ROADWAY PLAN
STA. 9+00 TO STA. 14+00
INTERSTATE ROUTE H-1 REHABILITATION
Middle Street to Vicinity of Ward Avenue
FAP NO. IM-HI-1(269)

"AS-BUILT"

INTERSTATE ROUTE H-1 REHABILITATION
Middle Street to Vicinity of Ward Avenue
FAP NO. 1M-HI-1(269)

SHEET No. R-04 OF 43 SHEETS

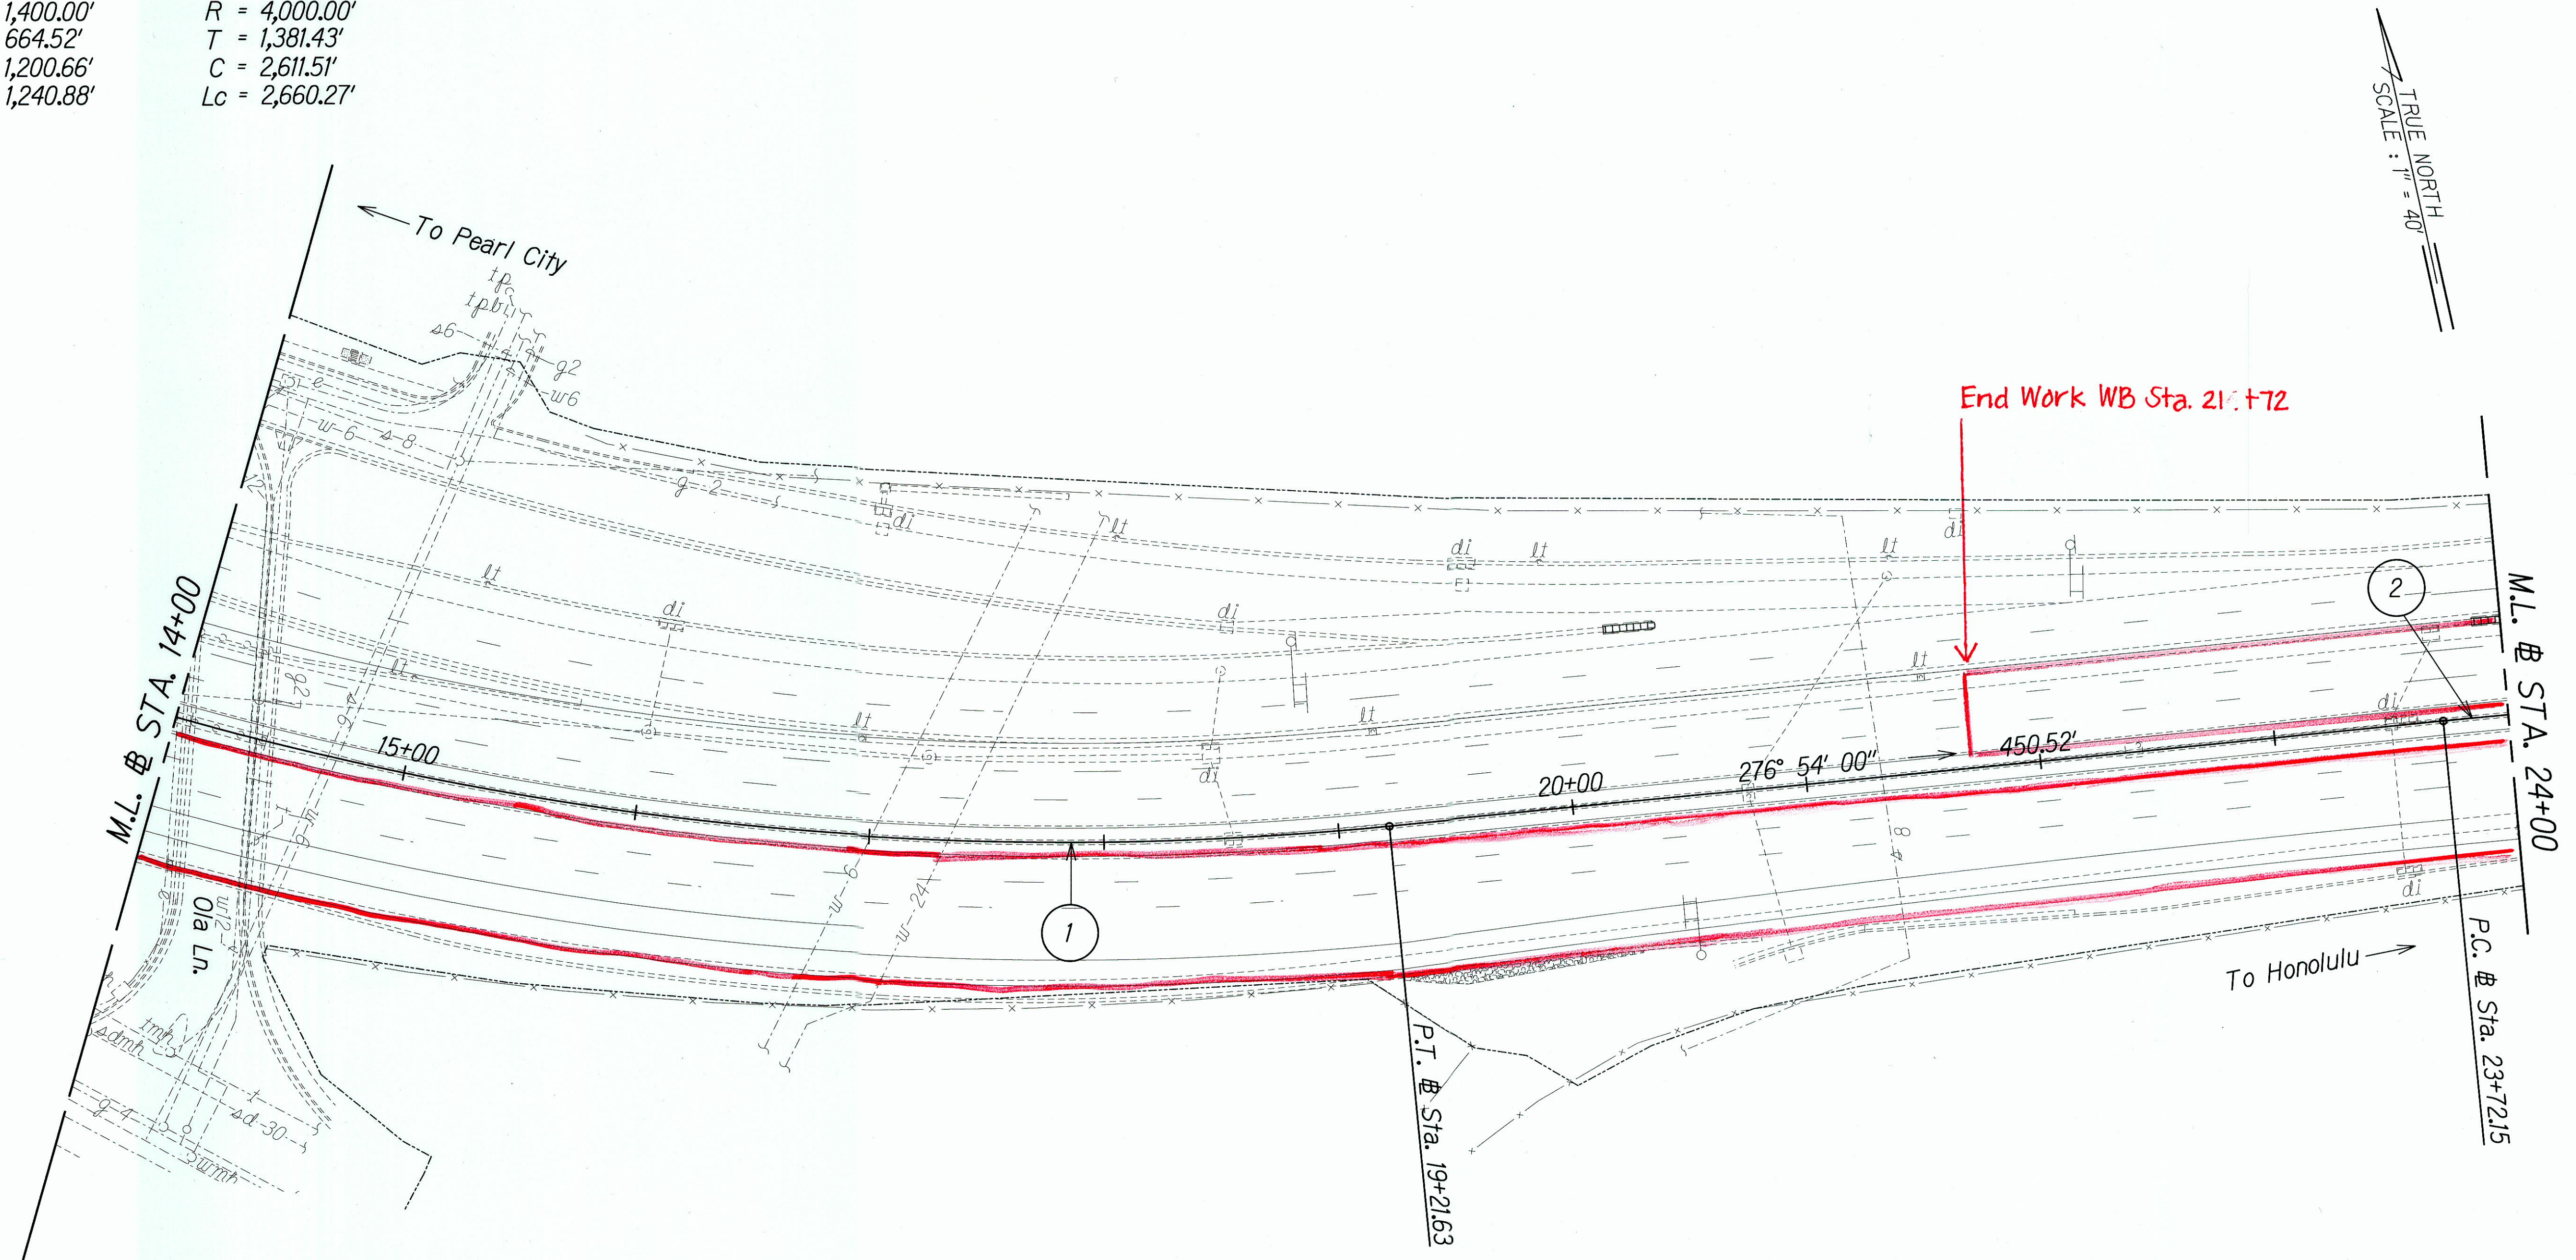
Section Highlighted in Red Box:
Cold Plane 2" depth, pave 2"
HMA Mix IV

ROADWAY PLAN

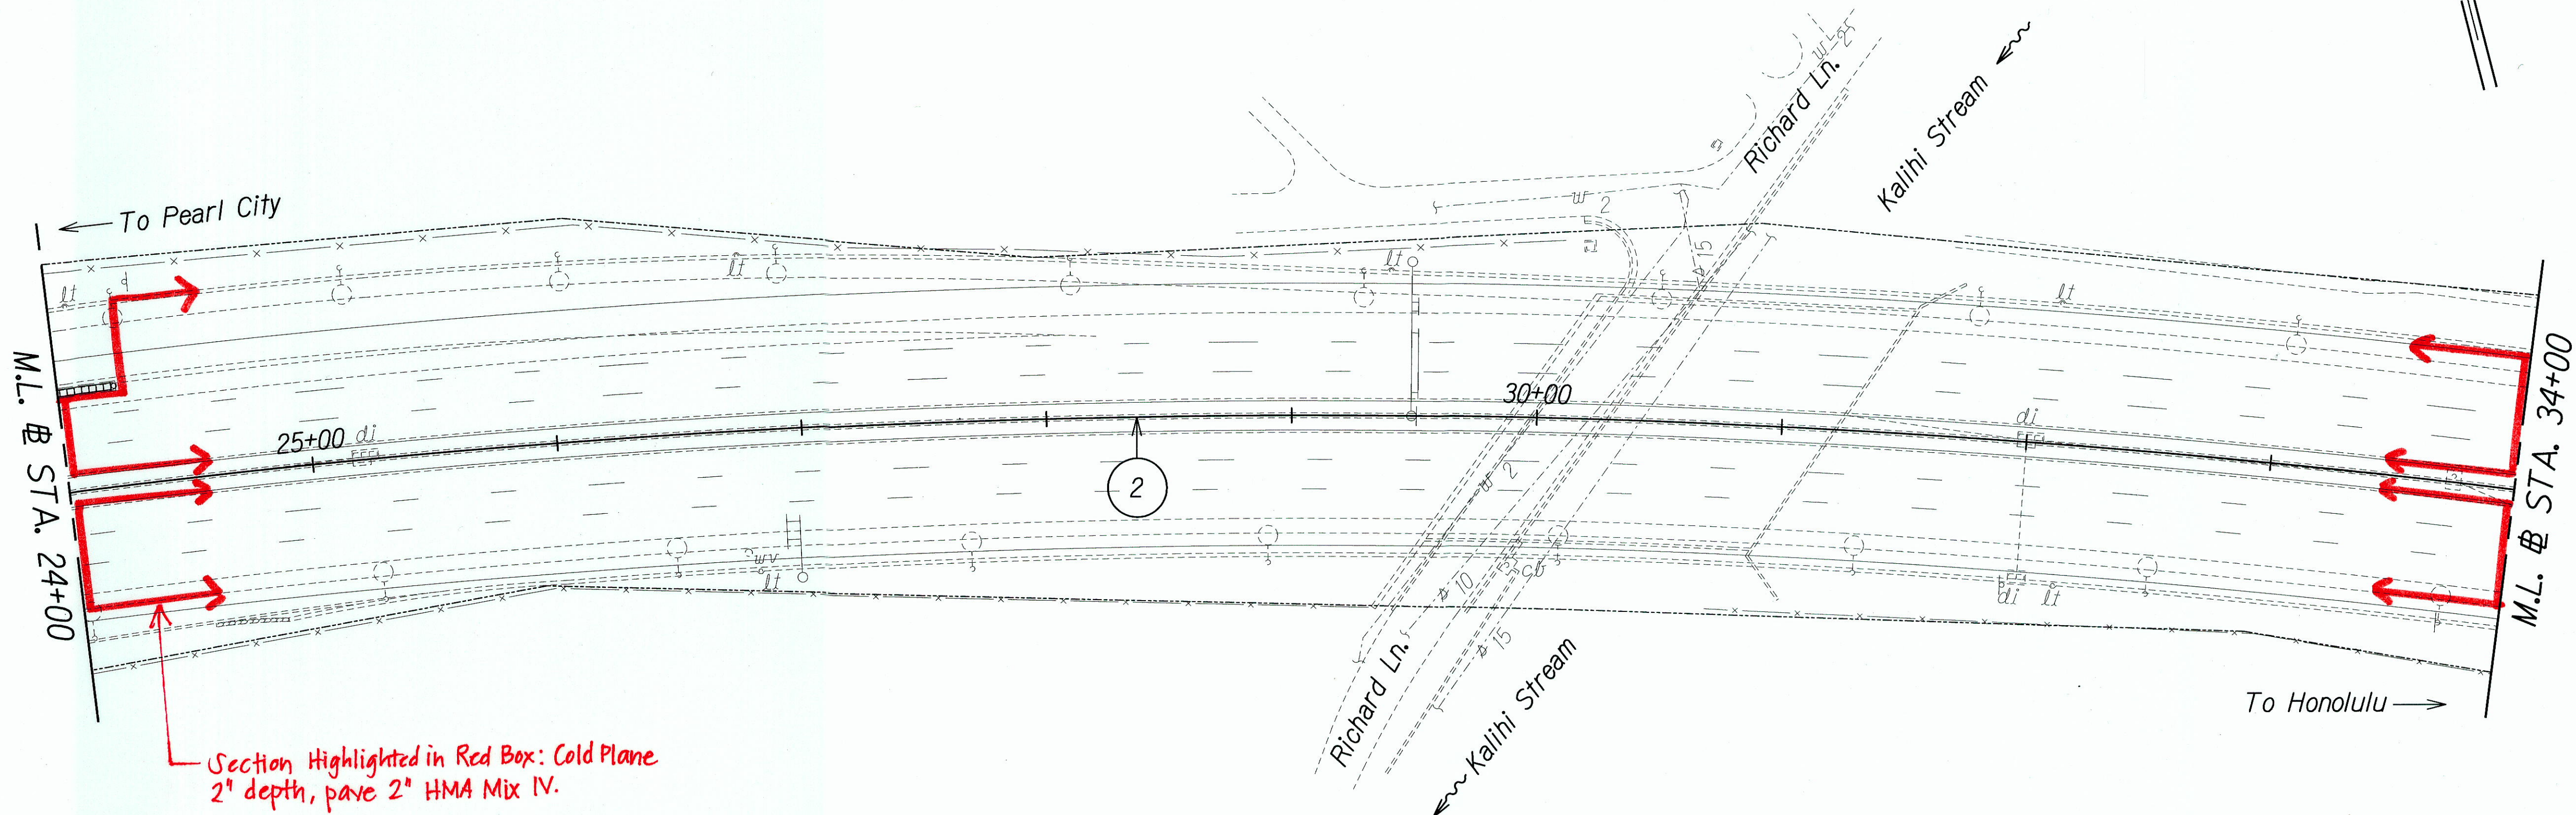
Section Highlighted in Red Box: Cold Plane
 2" depth, pave 2" HMA Mix IV.

ROADWAY PLAN
STA. 44+00 TO STA. 54+00
INTERSTATE ROUTE H-1 REHABILITATION
Middle Street to Vicinity of Ward Avenue
FAP NO. 1M-HI-1(269)

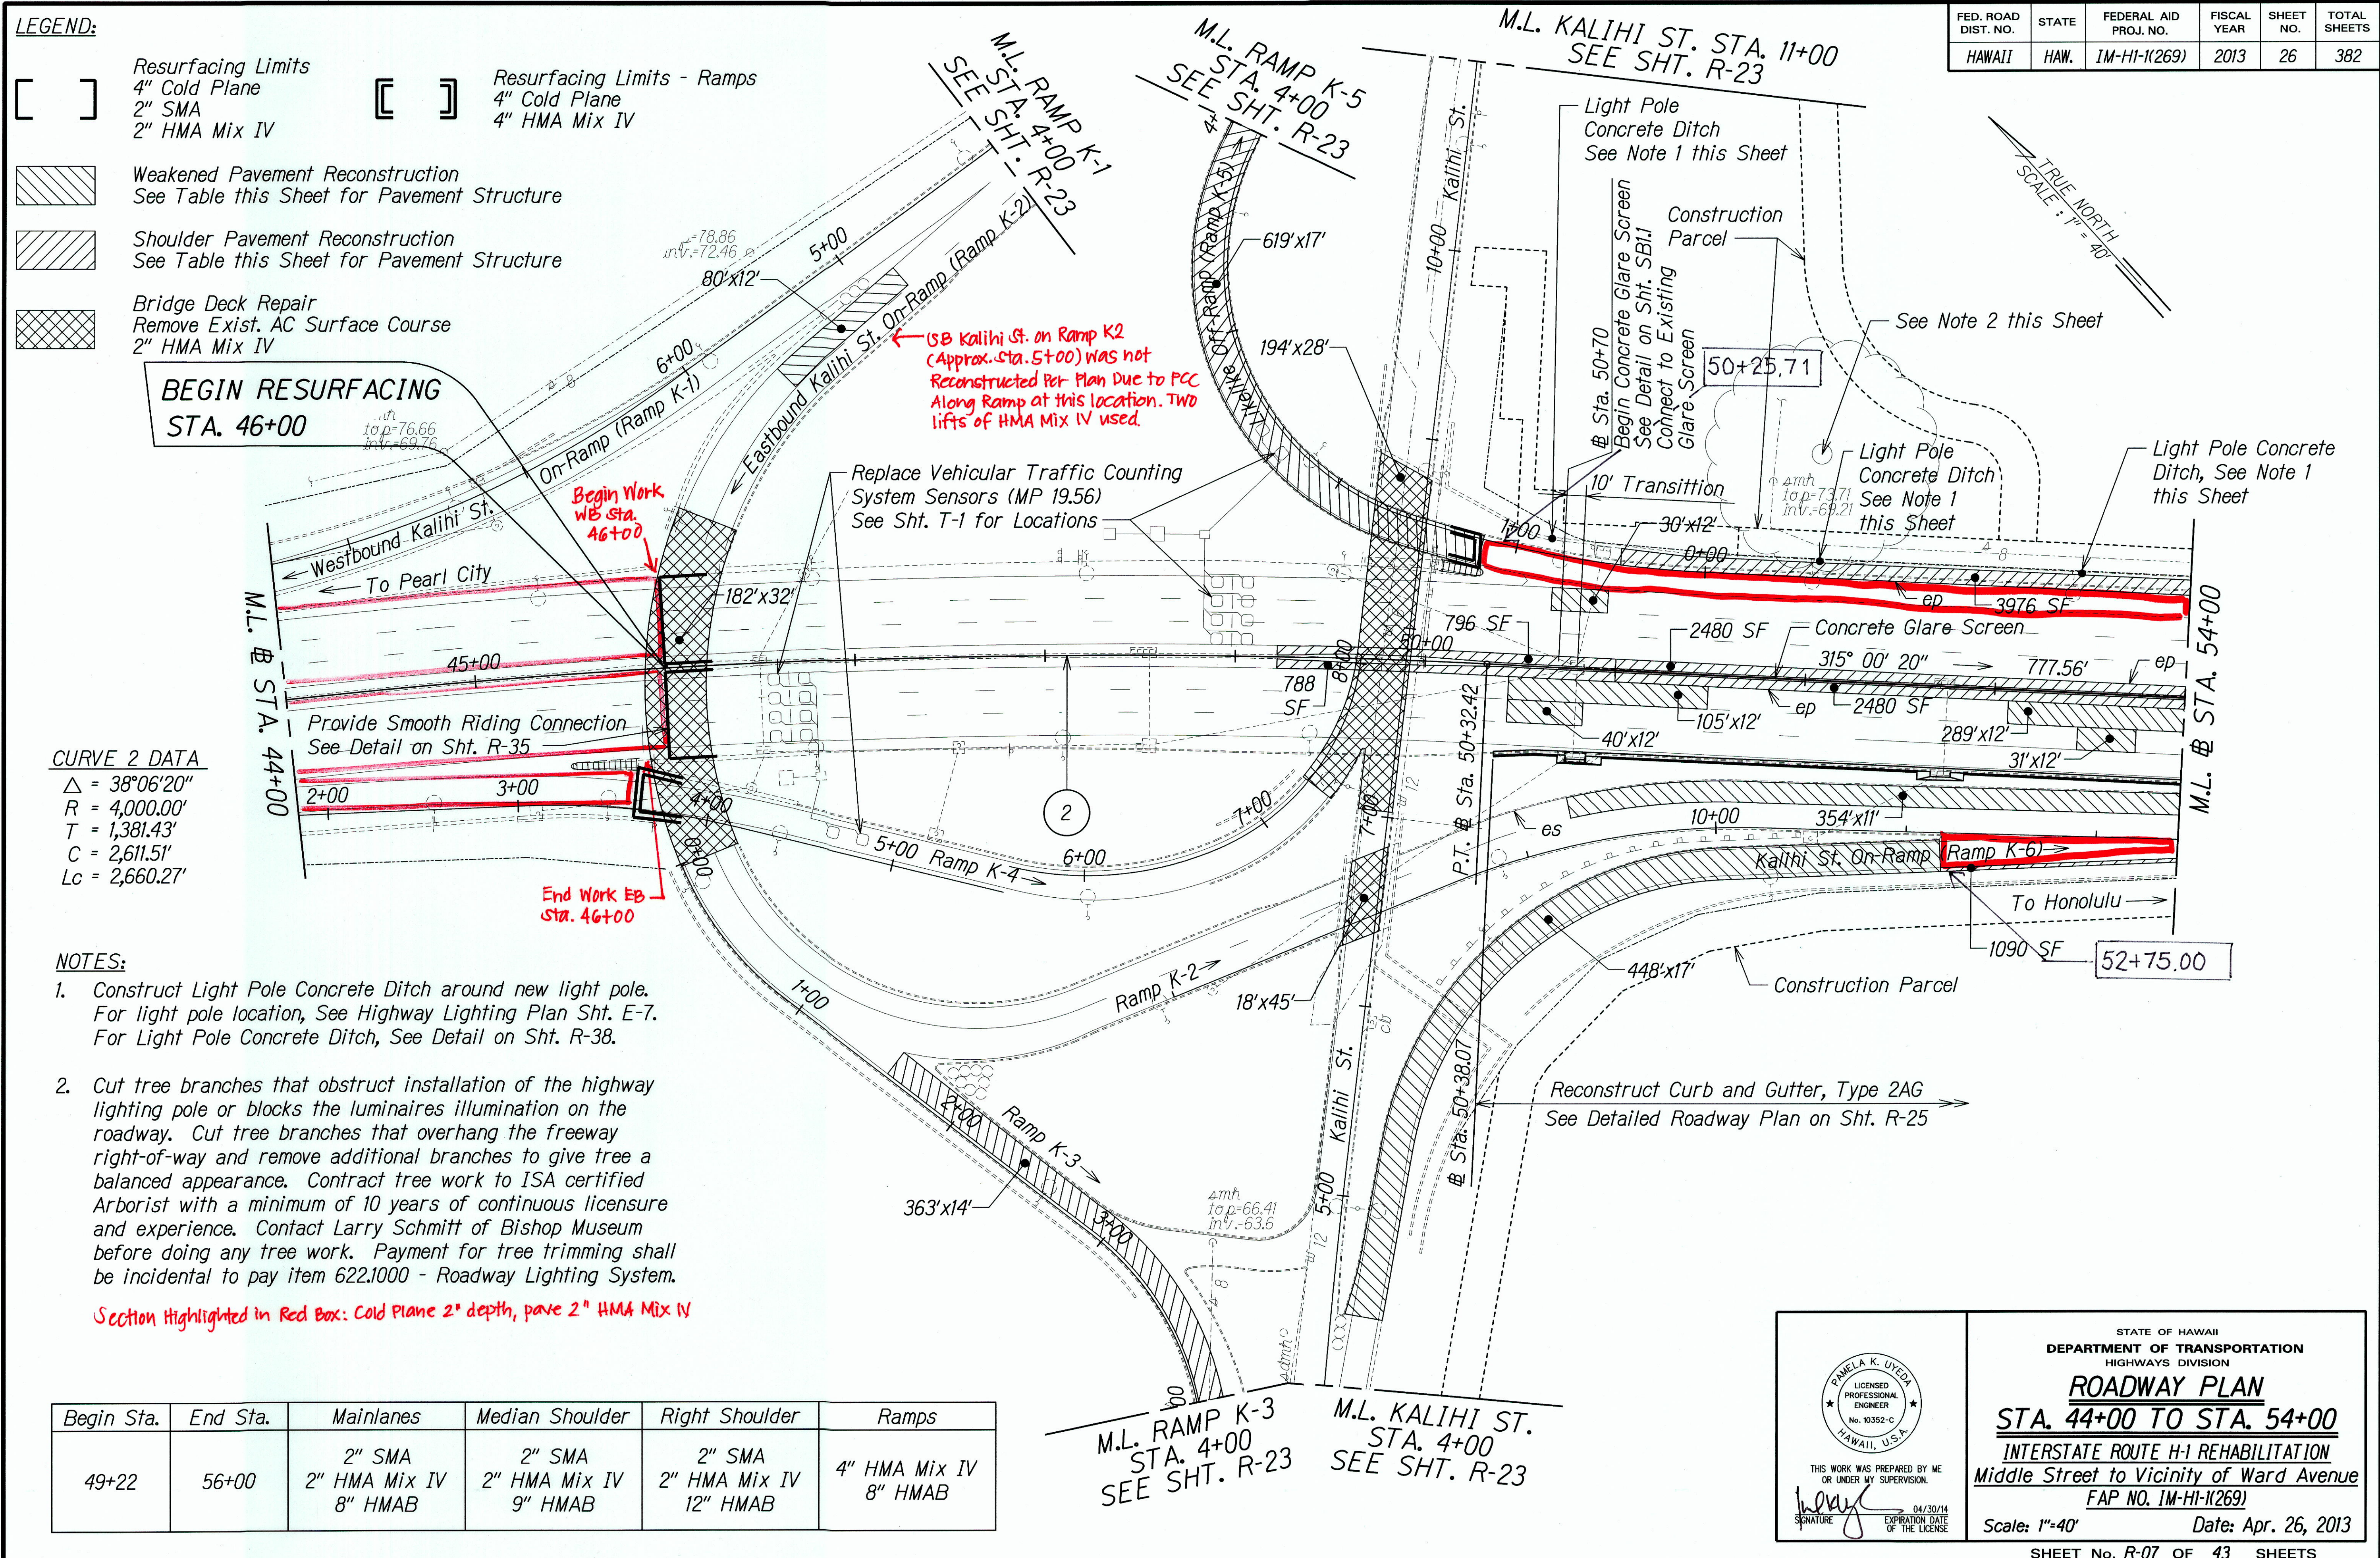
Section Highlighted in Red Box: Cold Plane 2" depth, pave 2" HMA Mix IV
